David Sheehan - 97100965
File Ref: DN24/0024

Application No. DN24/0024

Proposal: Notification of shop top housing with affordable housing
Property: 178-184 Willarong Road, 41-47 and 51 President Avenue, Caringbah

Figure 1: Example of comparison of 'Approved and Proposed' plans (Red represents approved, and blue proposed)

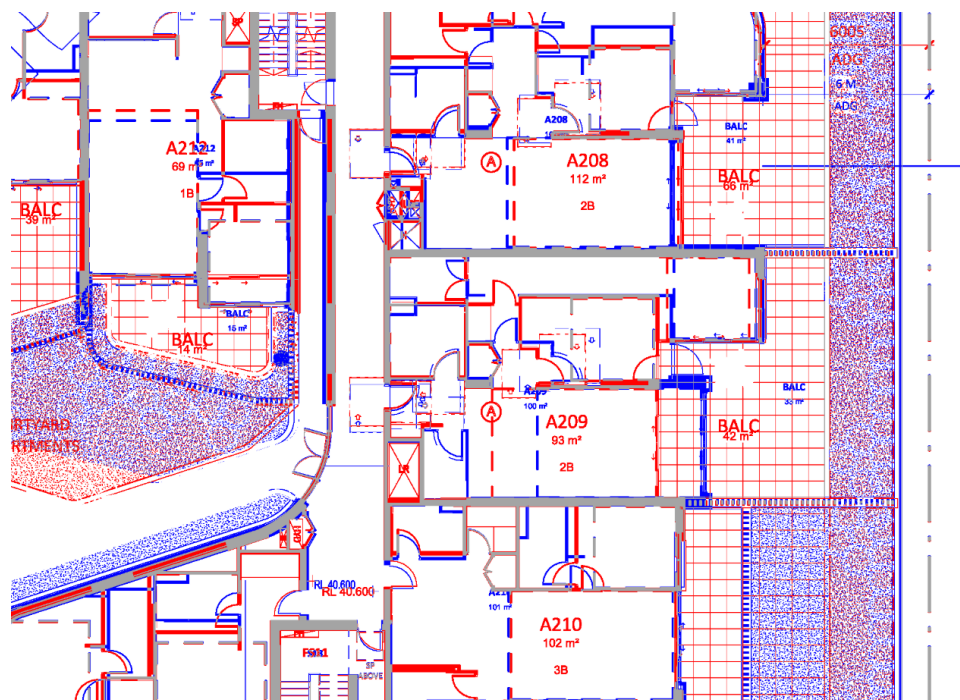
The relationship of this application to the existing approval under DA19/0333 is not clear. Upon initial review it appeared that this proposal might commence at Level 2, with DA19/0333 relating to work below this level, and facilitative, servicing and public domain works. However, upon further review, it was noted that there are several amendments to the previously approved design at all levels, and elevations. This includes amendments to the northern tower which are labelled 'AS APPROVED', however a comparison with previous plans indicate that these too are different. An example of such changes is provided below.

In terms of moving forward, if it is the intent that the SSD proposal replaces the current consent, it is requested that existing conditions are replicated in the SSD application. It would also be sensible to identify the 'cut off point' whereby works under the current consent cease to apply, and the new consent 'takes over'. It is assumed that HPC contributions will be applied to the current application, noting the lodgement date of the current proposal postdates the HPC Order.
